To: X3T9.2 Members
Subject: Small Form Factor
Date: October 9, 1992
From: Dal Allan

As per the recommendation of the September working group, the following is the proposal for an Informative Annex to be added to the draft proposed ATA standard.

Annex *: Small Form Factor Configurations
(informative).

FIGURE *-1: 50-pin Connector

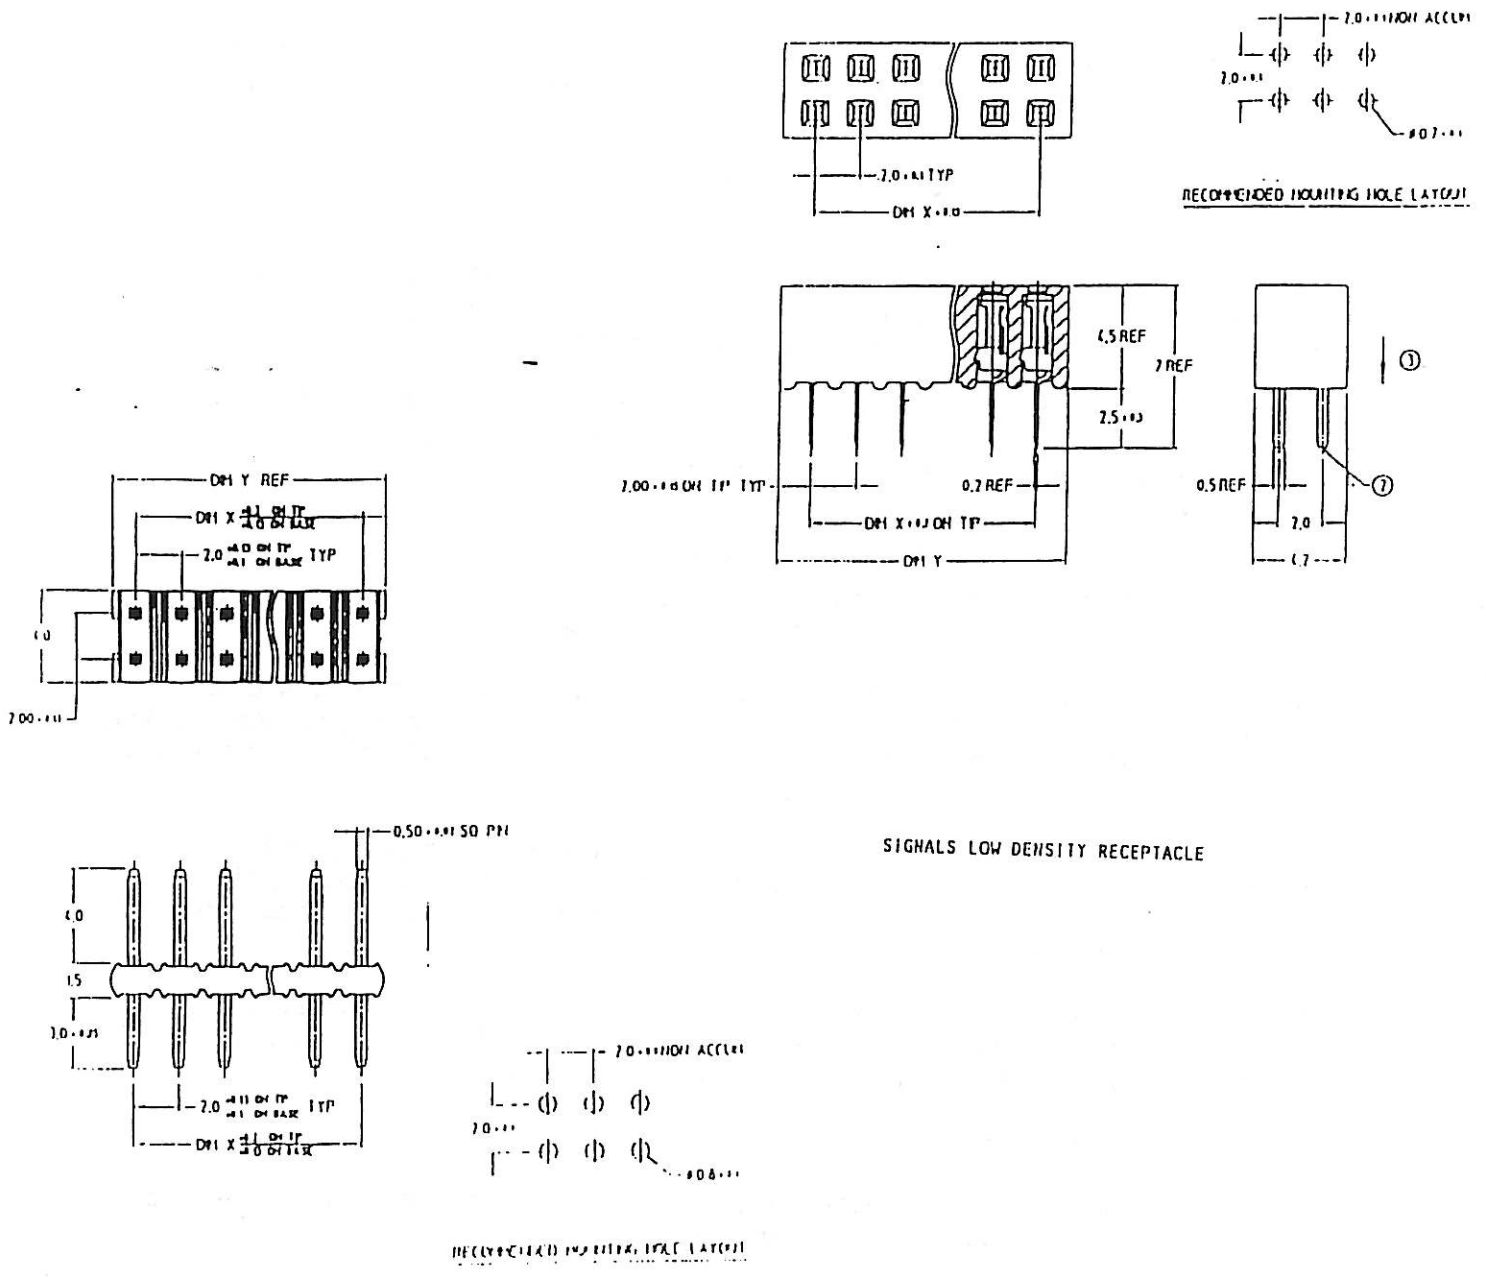
The signals assigned for 44-pin applications are described in Table *-1, and the 50-pin connector is described in Figure *-1.

The first four pins of the connector plug located on the drive are not to be connected to the host, as they are reserved for manufacturer's use. Pins E, F and K are keys, and are removed.
